Access Compliance Report Public Rights-of-Way (Pedestrian Signals)

Main Street: **ANTONIO_PKWY** Cross Street: **WINDMILL_AVE** Location: **W**

ADA ID: **SGRK211029140325** Signal Type: **One Push Button-APS** Overall Compliance: **No** Severity Scores: **BTN 1: 25** **BTN 2: N/A** **No BTN: N/A**

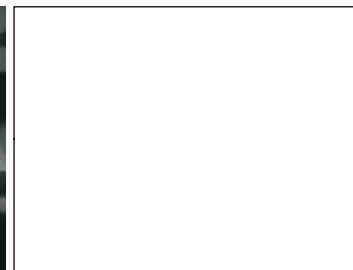
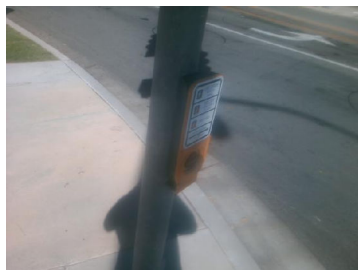
OC Std/PROW: R404.2

Possible Solutions: Remove and Replace Clear Space.
